HIGHWAY LIGHTING LEGEND
& KEY MAP

INTERSTATE ROUTE H-1 REHABILITATION
MIDDLE STREET TO VICINITY OF WARD AVENUE
FAP NO. 1M-HI-1(269)

"AS-BUILT"

HIGHWAY LIGHTING PLAN - F

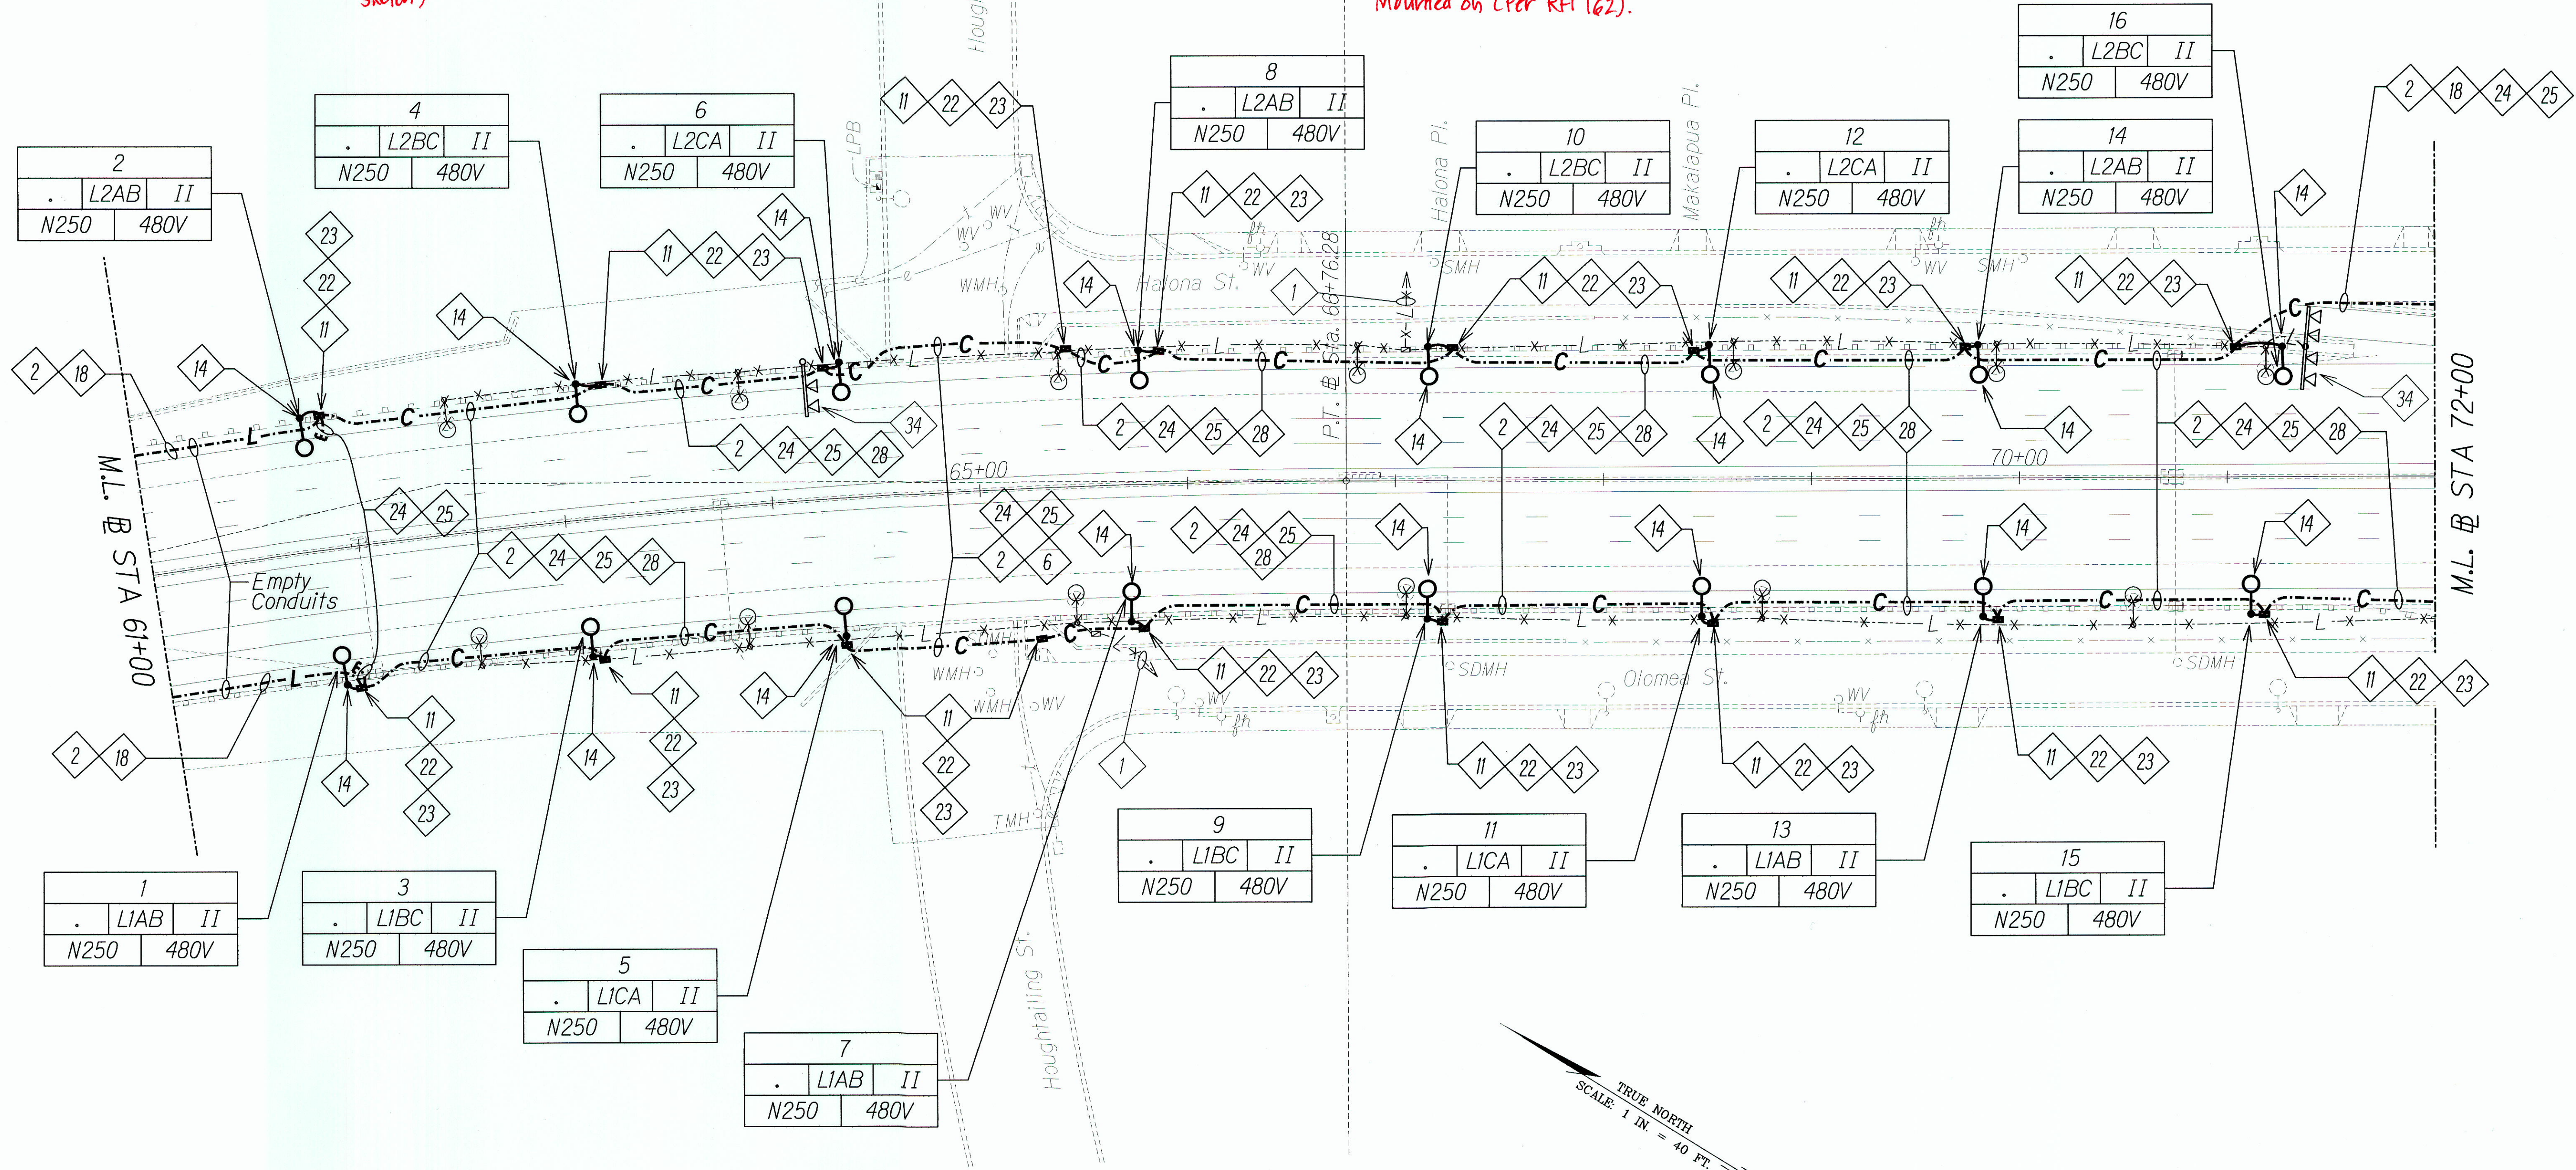
At the Houghtailing Underpass, Westbound, the Four 2" Conduits were installed on the wall with concrete Encasement for additional support and protection. (See RFI 165 for more info - attached sketch)

The Existing Street Light Bases Adjacent to New #8 and #10 WB can't be removed since they are feeding other Lights. Pole Bases were left in place with a Blank Steel Plate at top and Photocell Mounted on (Per RFI 162).

HIGHWAY LIGHTING PLAN - J

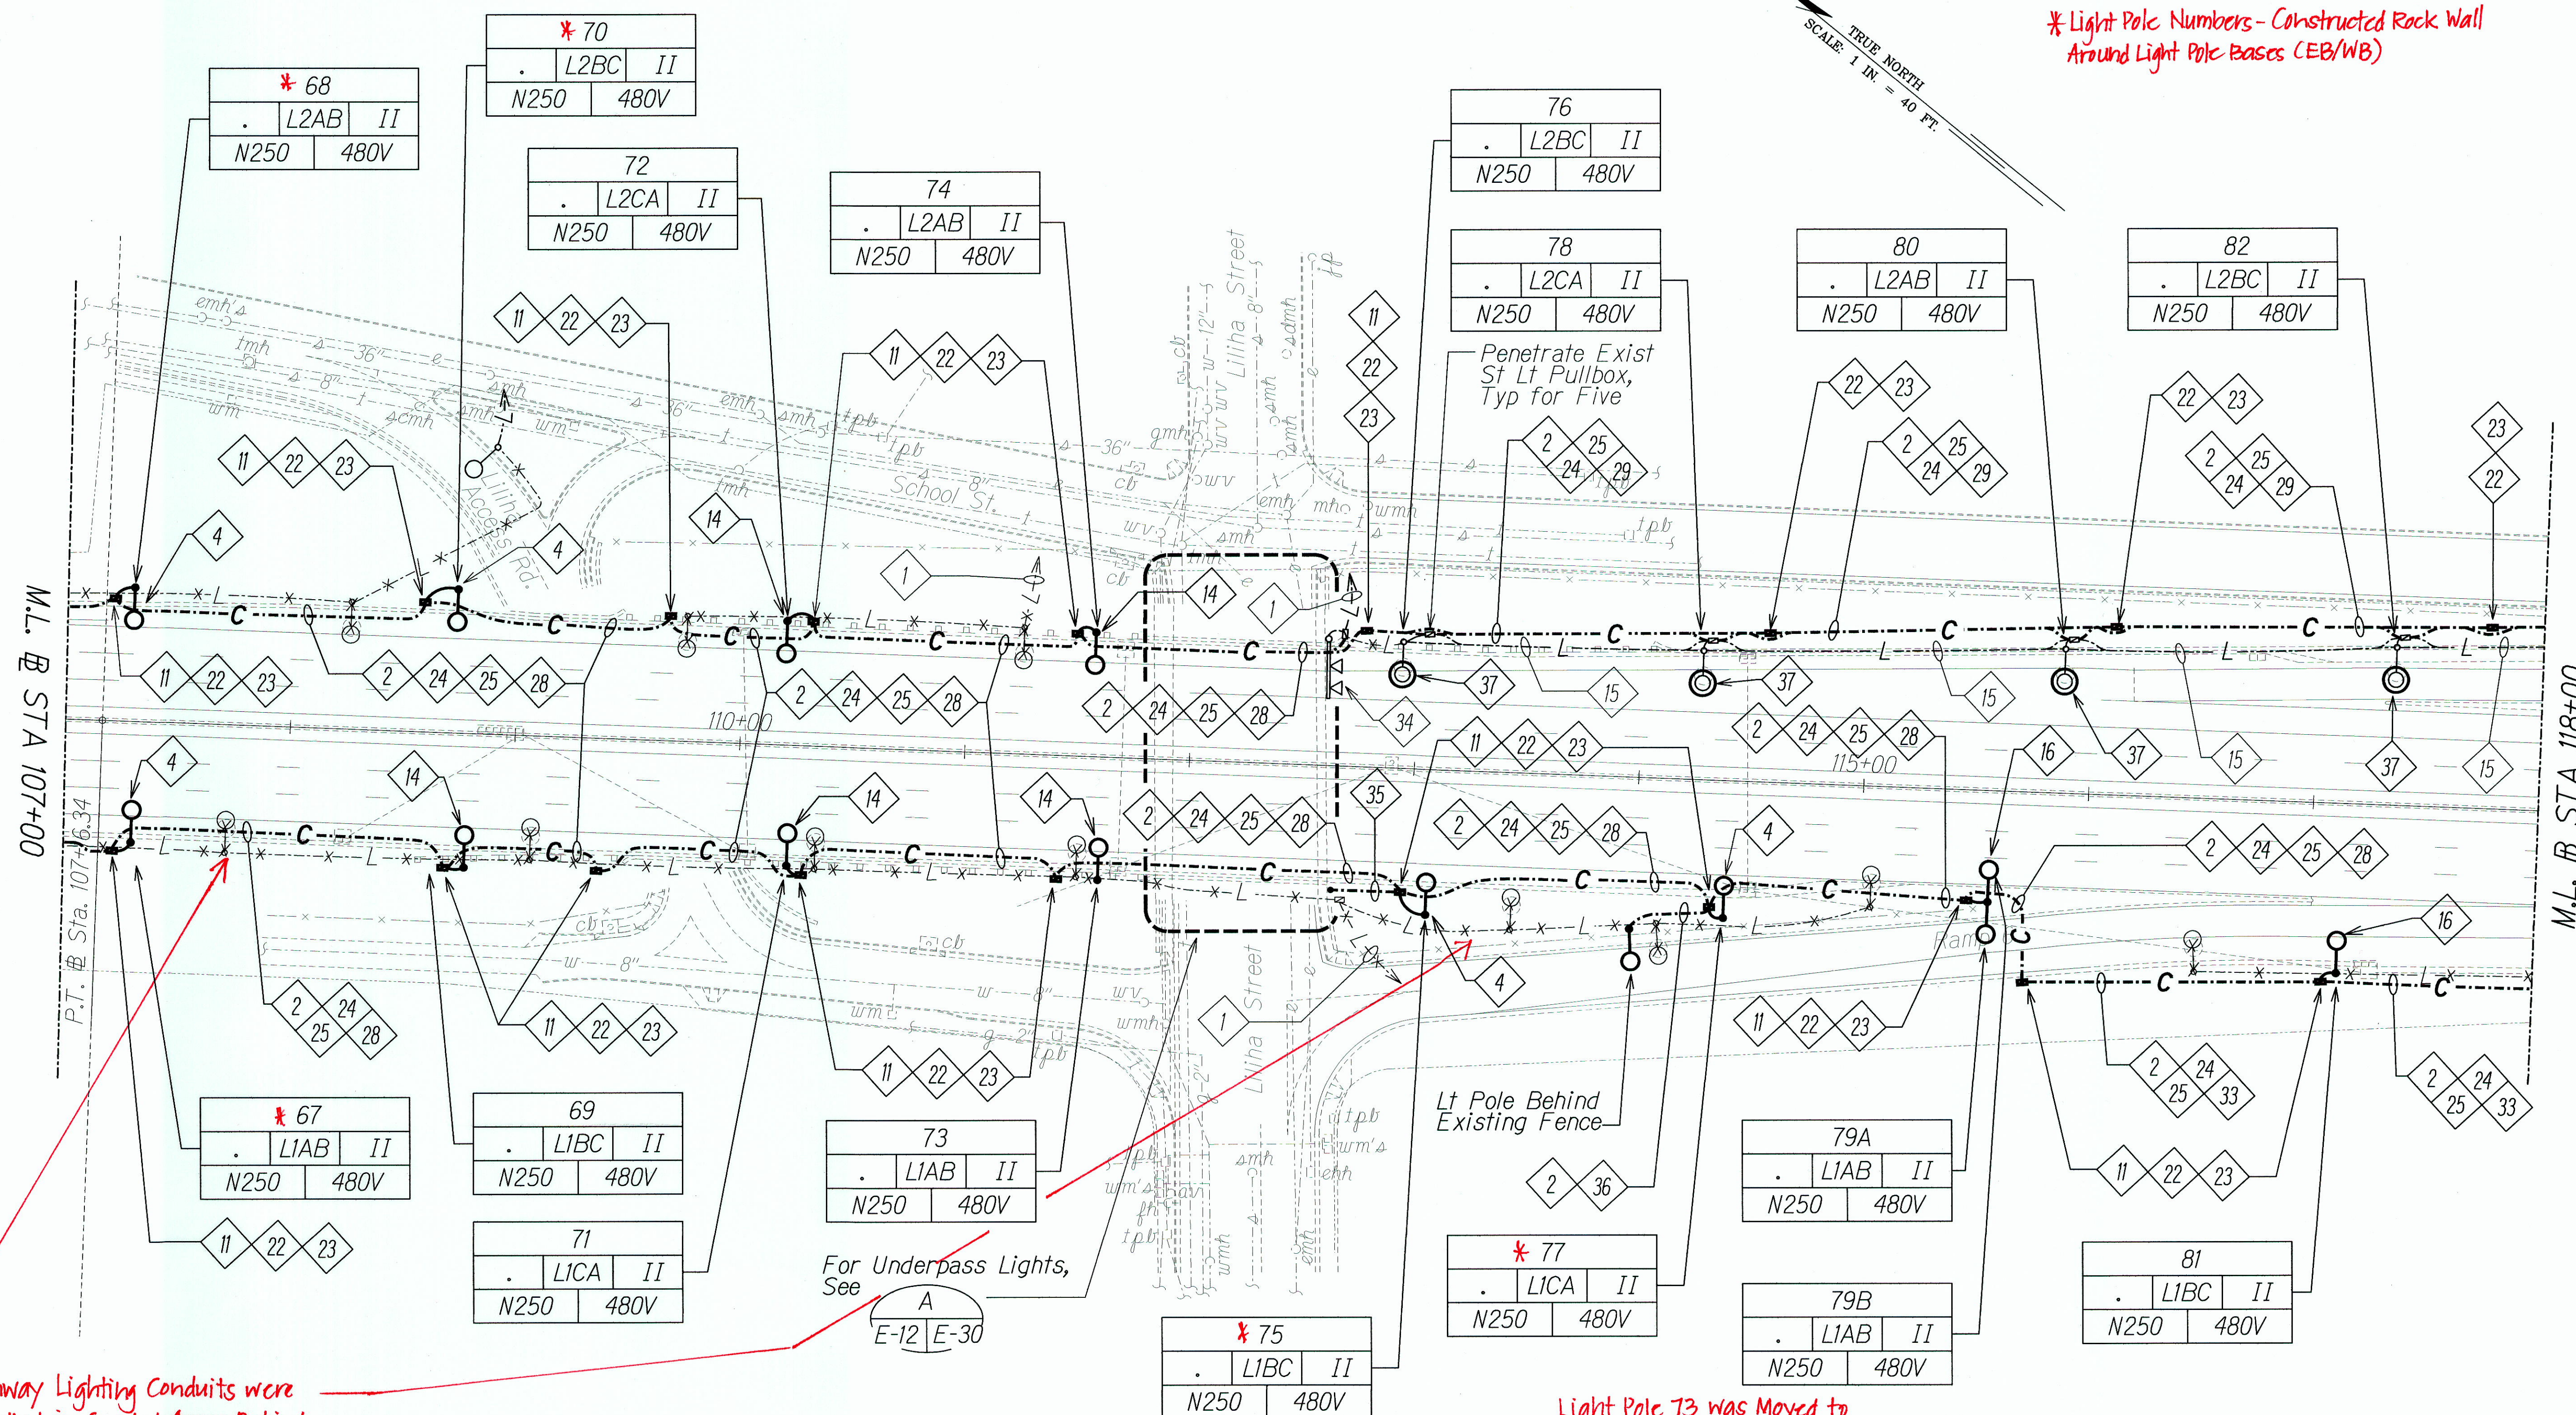
See Attached Drawing for Placement, Spacing, and Designated Cover for Conduits (Per RFI 72)

* Light Pole Numbers - Constructed Rock Wall Around Light Pole Bases (EB/WB)

Highway Lighting Conduits were Installed in Graded Areas Behind the Guardrail at Locations:
 Eastbound
 Sta. 113+06 to 115+57
 Sta. 107+30 to 109+28
 Sta. 141+25 to 143+58
 Sta. 146+12 to 146+62
 Sta. 147+40 to 149+05
 (Per RFI 052)
 *Also, see Pages 275 & 276

Light Pole 73 was Moved to Sta. 111+50 due to Conflict with Existing Drainline (Per RFI 079)

HIGHWAY LIGHTING PLAN - K

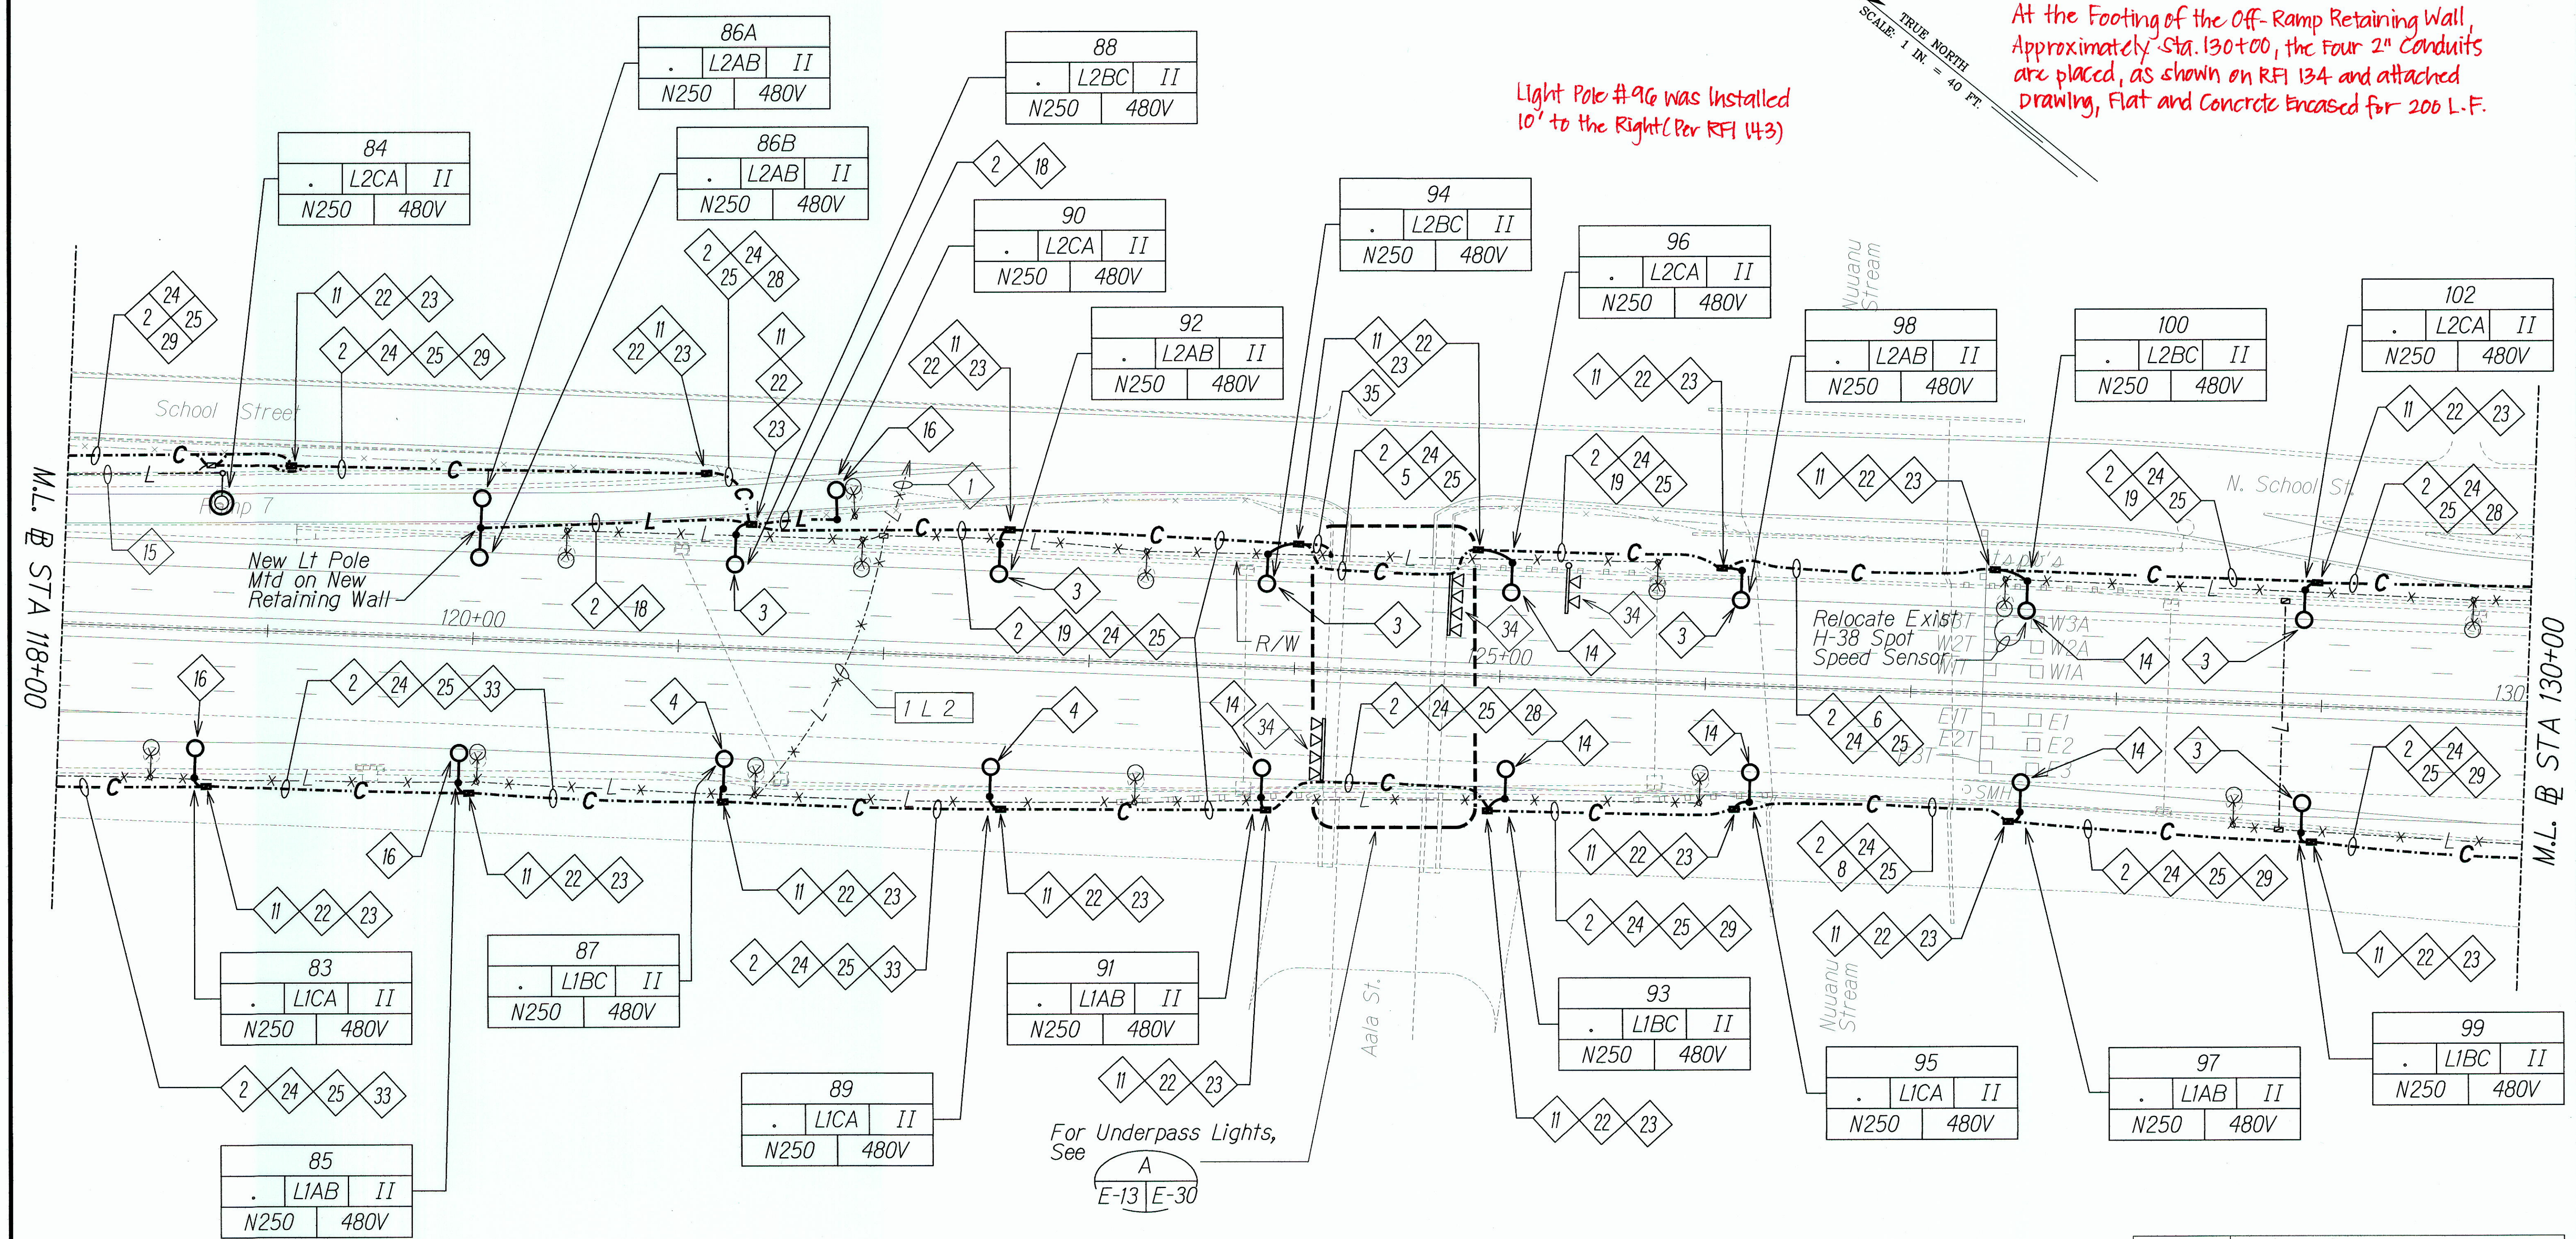
Light Pole #83, 85, 87, & 89 - constructed
Rockwall Around Light Pole Bases (EB/WB)
